*City of Jonesboro Metropolitan Area Planning Commission*  
**Staff Report – RZ 15-04: 3298 Colony Drive Dustin Apartments**  
 Municipal Center - 300 S. Church St.  
*For Consideration by the Commission on April 14, 2015*

**PURPOSE:** A request to consider recommendation to Council for a rezoning from “R-1” Single Family Residential District to “RM-6” Residential Multifamily/Four-plex Apartments

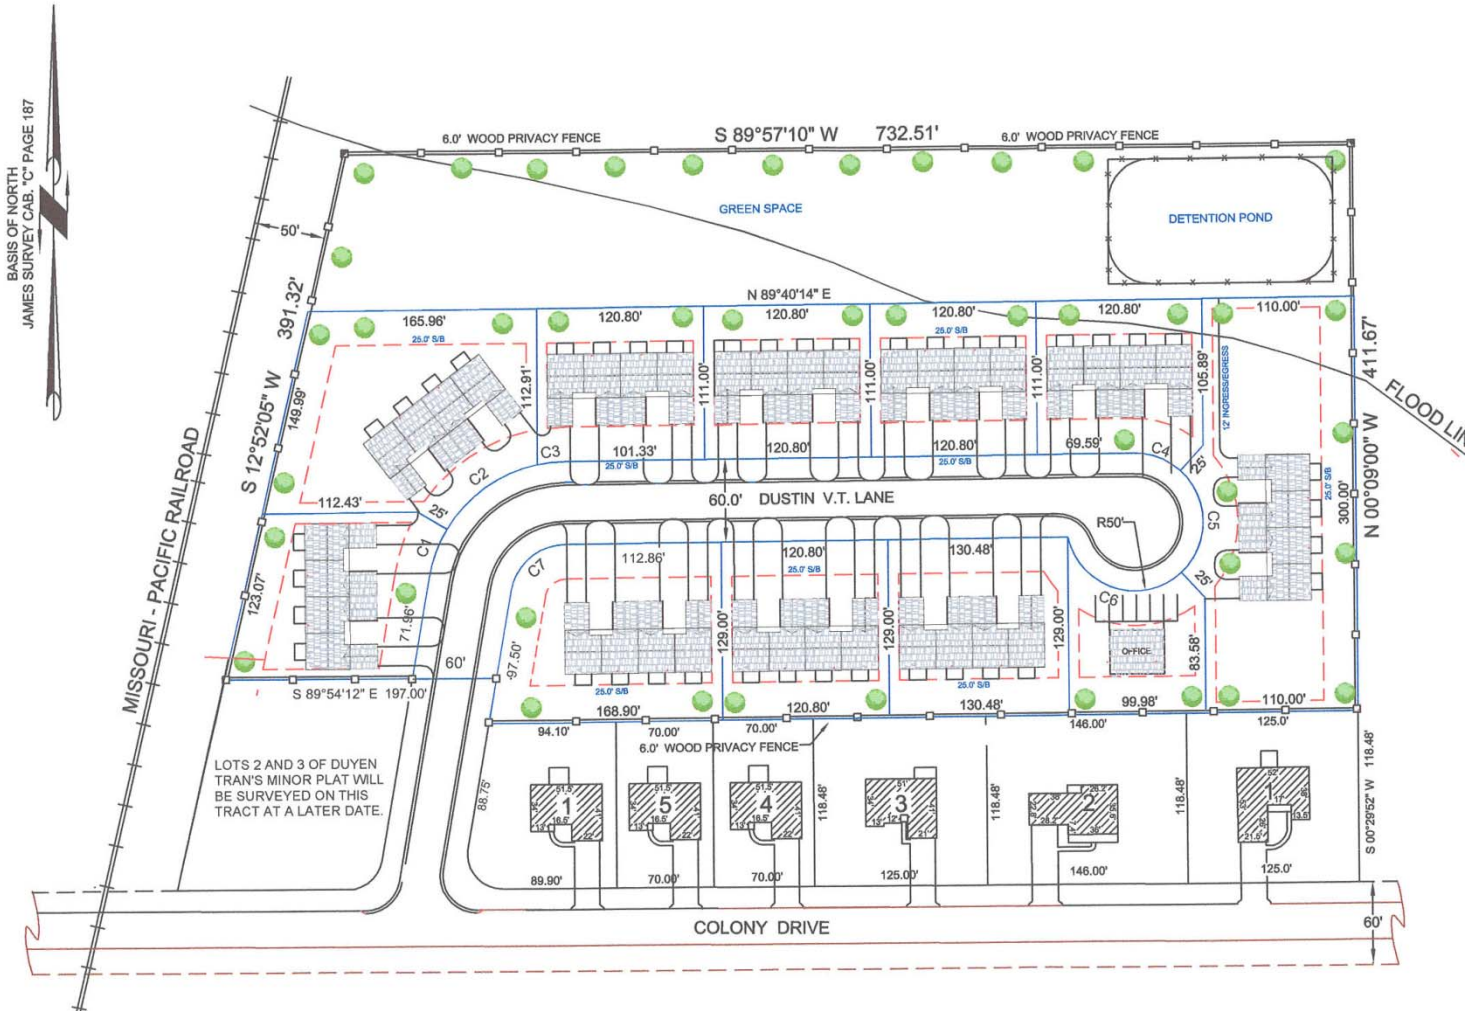
The graphic layout above depicts the 10 proposed buildings, having 4 apartment units in each with a small office for common area and management purposes (on 11 individual lots). The proposed layout strategically places the attached units away from the main roadway (Colony) to allow a visual buffer. Additionally, the owner has located a 2.0 acres +/- buffer/greenspace area and detention pond to the north, to buffer other single family properties fronting on Leatherwood Ln. The owner also owns Lots 2 and 3 of Duyen Tran's Minor Plat, located at the southeast corner/frontage of the property entry way. This parcel is to be single family residential only, and will serve as a buffer for the proposed development. A 6-ft. wood privacy fence is also added for security and visual screening as well.

The developer/owner plans to extend a private drive (Dustin Drive), northerly from the terminus of a public proposed street. A waiver of the 400 ft. maximum Cul-de-sac extension needs to be granted by the Planning Commission, due to the proposed private drive exceeding the requirement. Possible revisions to the layout could be

made by the designer to allow for Dustin Drive to extend a stub-out to Leatherwood fronting properties to the north.

5. The property shall be redeveloped under the “RM-6” standards and guidelines with a maximum of 40 Apartment units.
6. The proposed private drive must meet the requirements of the MAPC in terms of access management. A feasibility study should be conducted and presented to the MAPC in terms of allowing for Dustin Drive to extend a stub-out to Leatherwood fronting properties to the north, during the Final Site Plan review and approval.
